Subject: PROJECT NOS. 3 AND 5
 DOCKET NUMBERS 50-508 AND 50-509
 FINAL REPORT OF POTENTIAL 10CFR50.55(e)
 ITT-GRINNELL PIPE HANGER STIFF CLAMPS (D/N #31)

ENGINEERING FINAL REPORT

ITT-GRINNELL STIFF CLAMPS
DEVIATION/NON-COMPLIANCE 031

REVISED
DECEMBER 8, 1981

FIGURE 215 STIFF CLAMP

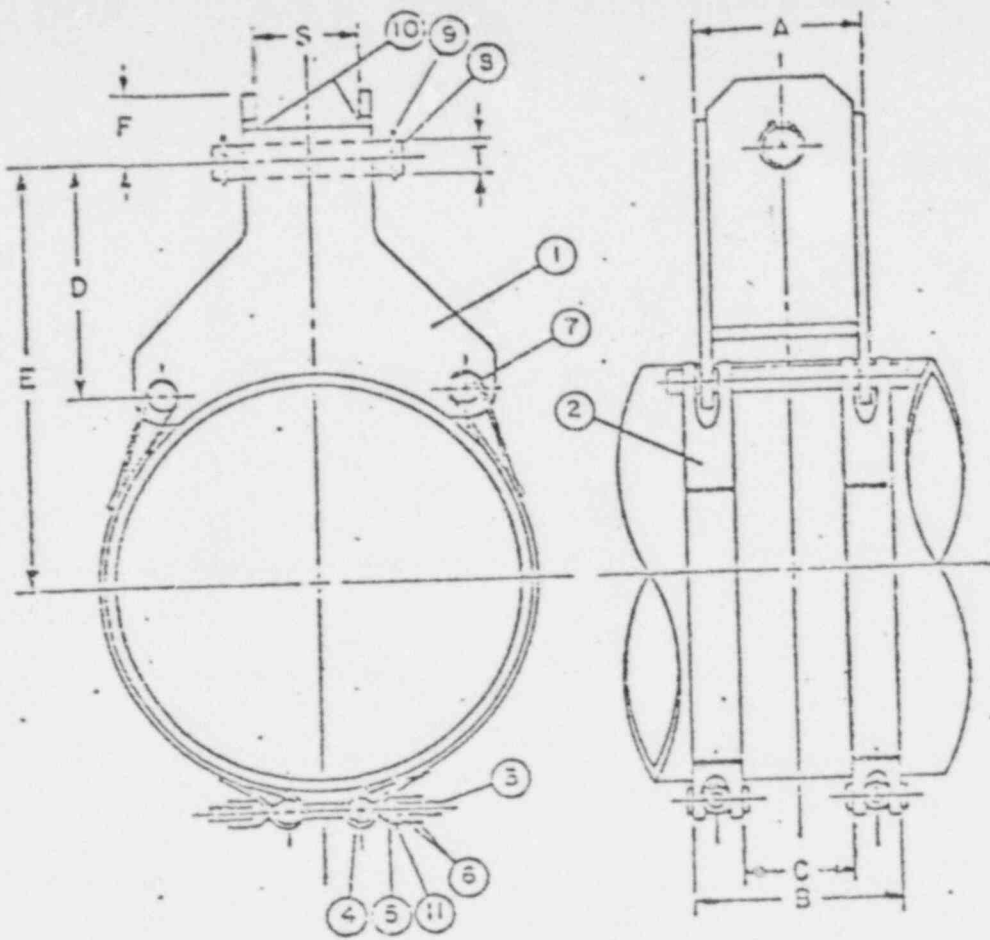
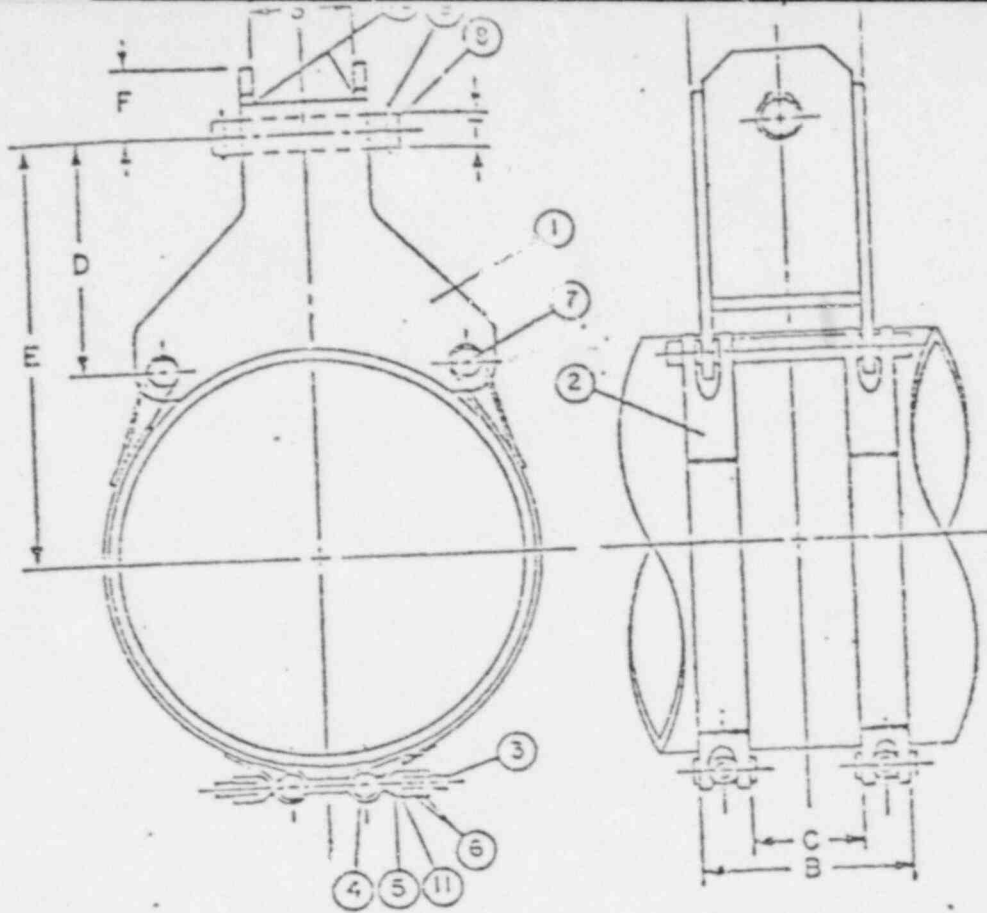
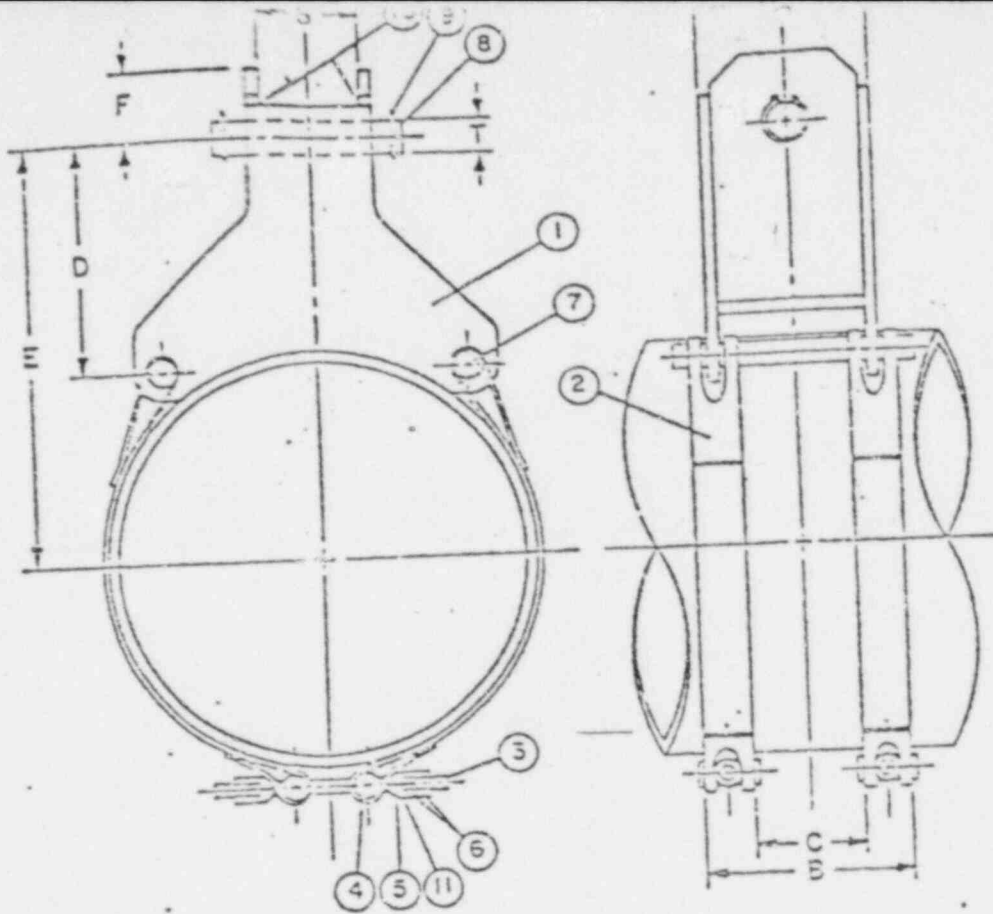
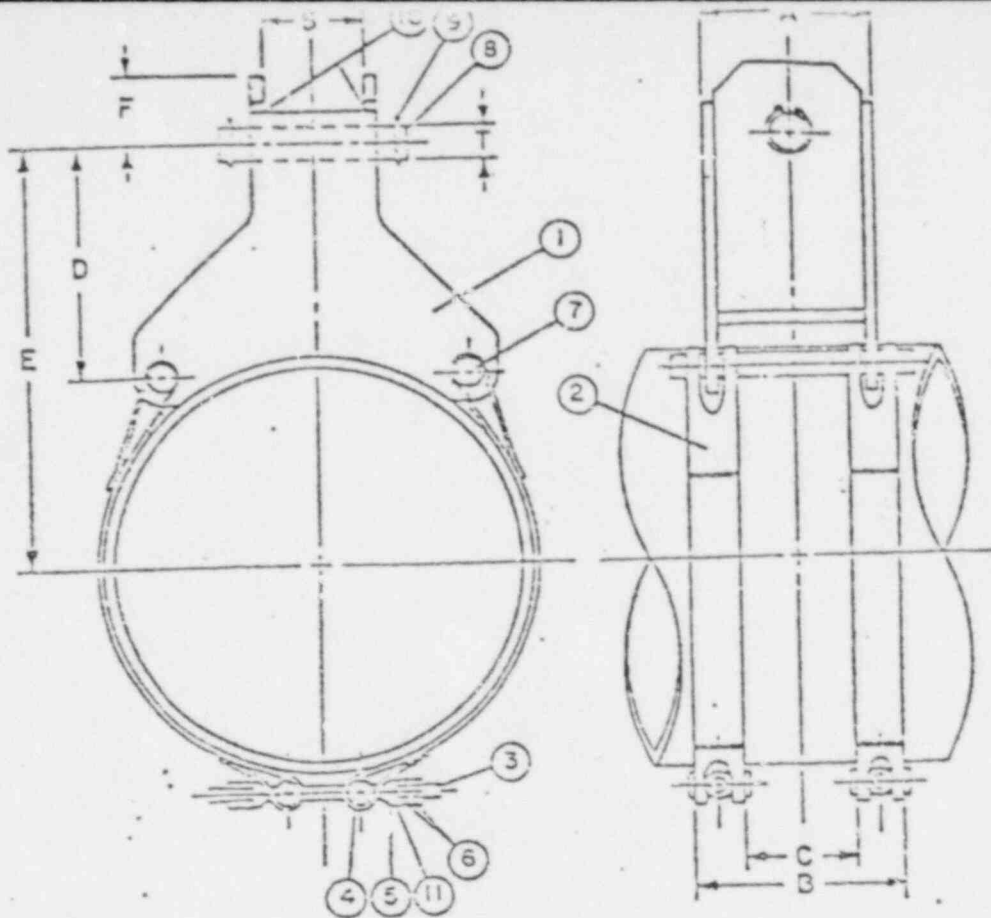
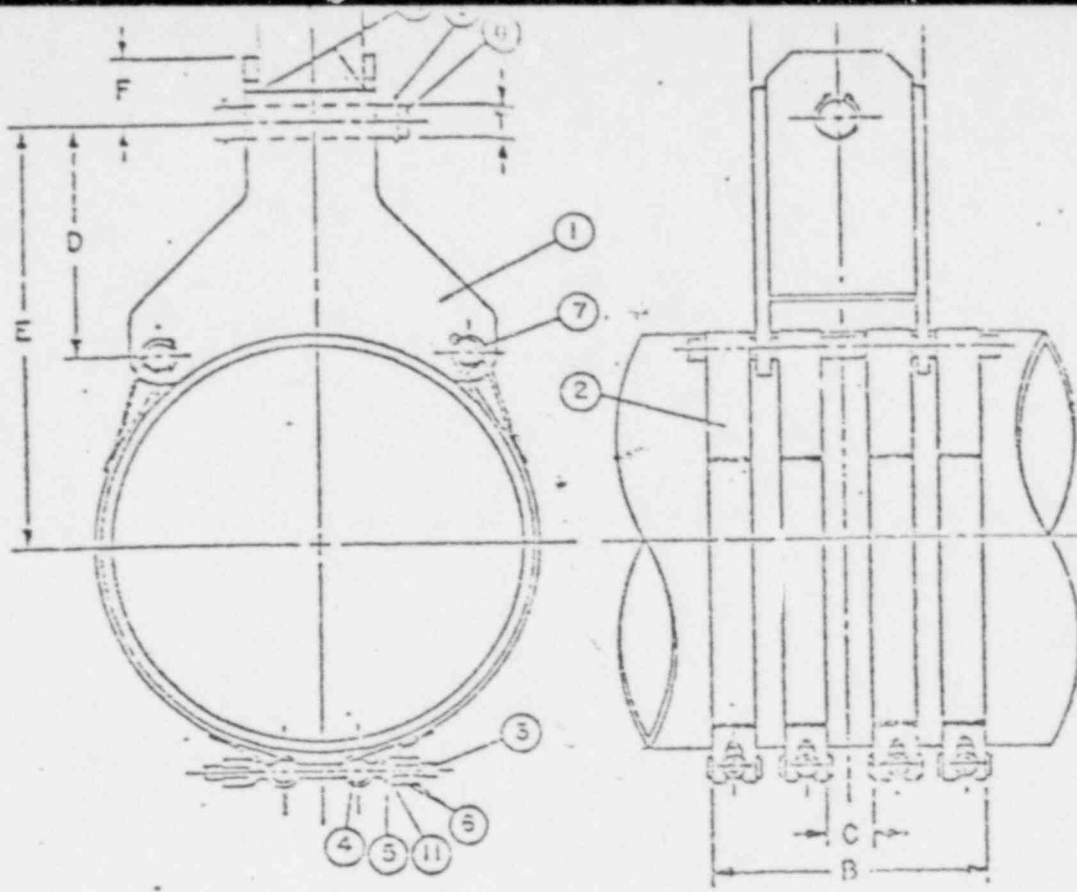
In response to this requirement ITT-Grinnell designed the Fig. 215 Stiff clamp as shown in Attachment 1. To obtain the desired stiffness the strap assemblies are pre-loaded by torquing the hex nuts against the hardened rocker washer which pulls on the straps to provide enough pre-tension so that the load required to lift the yoke (Item #1) off the pipe is equal to the faulted load of the largest snubber/strut assembly that could be attached to that clamp. This means that the deflection caused by the load applied to the load pin (Item #8) will be a function of a load pin and yoke deflection until the faulted load of the clamp is exceeded.

Under normal conditions, the torquing process should cause the rocker washers and trunnions to rotate so that they align themselves on the tie rods. This ensures that the torque applied at the tie rods goes into supplying the required pre-tension to ensure proper function.

Tie Rod bending was identified during installation of initial stiff clamp assemblies and confirmed during subsequent mockups at the site. Bending was attributed to high friction between the strap loop, rocker washer and the trunnion. This friction locks the trunnion within the strap loop and prevents the trunnion from maintaining true alignment with the tie rod as the assembly is tightened. The trunnion rotates with the strap loop as the assembly is drawn together causing the trunnion to impart a bending moment to the tie rod.

Torque relaxation was identified during initial installation and subsequent mockups at the site. The cause of this relaxation is attributed to the high friction between the trunnion and the strap and between the rocker washer and strap. This high friction does not allow the strap loop to achieve equal loading beyond the points of tangency with the trunnion and rocker washer. Subsequent slippage of the strap between the trunnion and rocker washer will result in a loss of stiff clamp rigidity and attendant torque relaxation. IIT-Grinnell has advised that torque relaxation did not occur during original qualification testing.

III-GRINWELL MODIFIED FIGURE 215 STIFF CLAMP ASSEMBLY

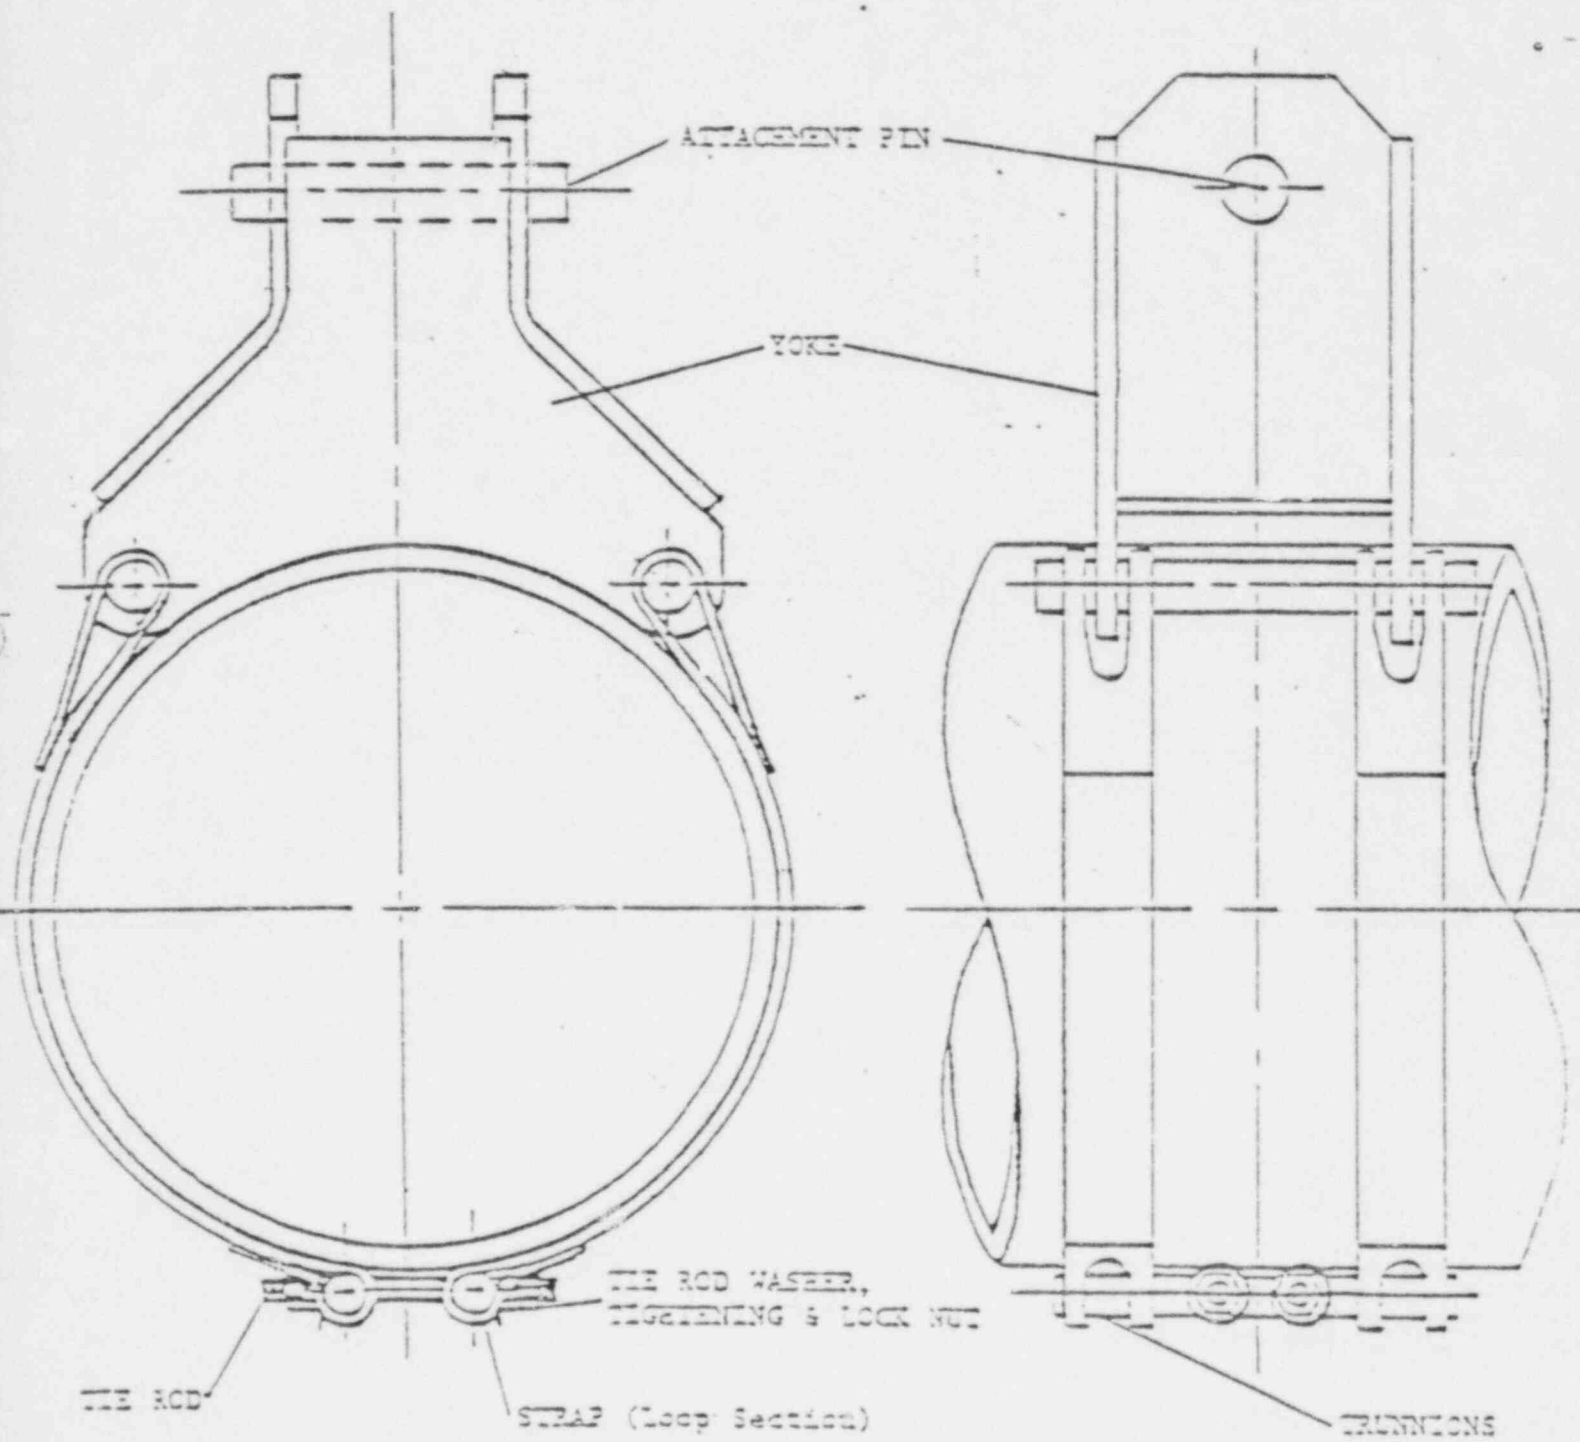
As a result of the concerns identified with the original Figure 215 stiff clamp design, it was subsequently determined by IIT-Grinnell that a modification to the original stiff clamp design was required. (Attachment 6)

1. The rocker washer assembly was removed.
2. The trunnion design was modified so that the two (2) straps on each side of the clamp assembly utilized a single trunnion rather than two (2) separate trunnions.
3. The trunnion material was changed from SA-36 to SA-193 Gr. B7.
4. The location of the tie rods was changed so that pre-torque is applied in-board to the straps.
5. Hardened steel washers were added under the tie-rod hex nuts.

Tie Rod bending discovered during installation and subsequent testing of the original Figure 215 clamp has been eliminated with the modified clamp design described above. Removal of the rocker washer eliminates the binding between the trunnion and straps and reduces the excessive friction at this point which was preventing the trunnion from rotating freely about the rocker washer and causing the tie rod to bend. In addition, it was found during ITT-Grinnell's requalification test, that the applied torque needed to achieve design requirements was significantly less than those originally specified (due to removal of the binding/friction problem), which is also a factor in eliminating the tie rod bending. A comparison of the torque values specified for the original and modified Figure 215 stiff clamps shows the following:

Torque relaxation identified during installation and subsequent testing of the original Figure 215 stiff clamp design has been eliminated with the modified clamp design described above. Removal of the rocker washer and modification of the trunnion and tie rod design relieves the excessive friction forces brought about from binding of the strap between the rocker washer and trunnion. This allows for equal strap tensioning and load distribution with essentially no resultant torque relaxation. For clamp sizes where normal torque relaxation may occur, ITT-Grinnell has added additional torque to the straps to insure that specified stiffness requirements are met. Details of the requalification test results and procedures regarding torque relaxation are provided in Attachment 8.
